RE: Field Issue of top plate connection, over-bored rim joist, and basement slider header for Lot #19A/B – Lee's Summit, MO 64082 – Permit # PRRES20214081

City of Lee's Summit Comment:

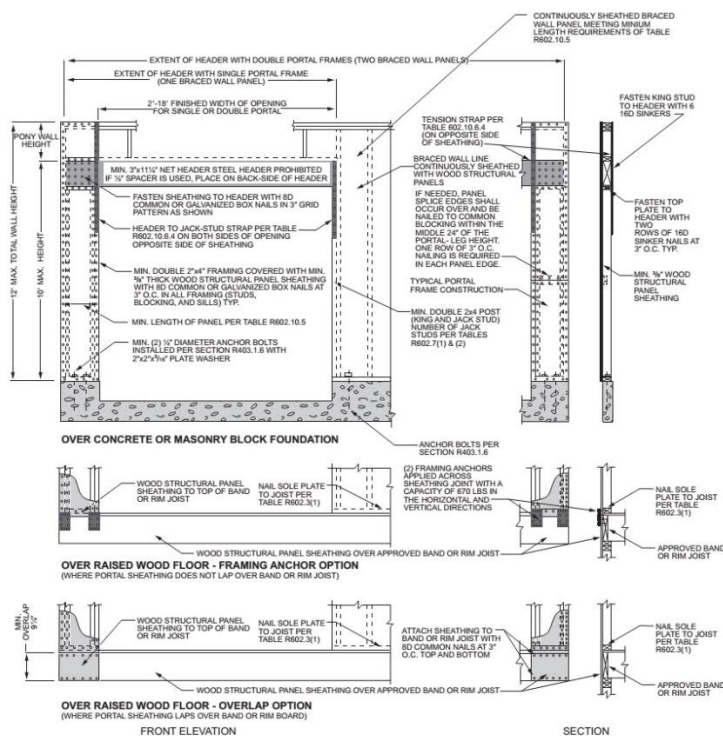
2. Over-bored rim (Unit A):

- Rim has over-bored for electrical lines.
- Hole is approximately 4" diameter and 3" from the bottom of the rim.
- Hole is approximately 2' from the closest end support.

- Install a (2) #2- 2x6 header beneath the over bored rim.
- Header shall span over the patio door and be supported by (1) jack stud.
- Shim gap between the top plate and rim with DFL#2 wood shims or steel shims as needed.
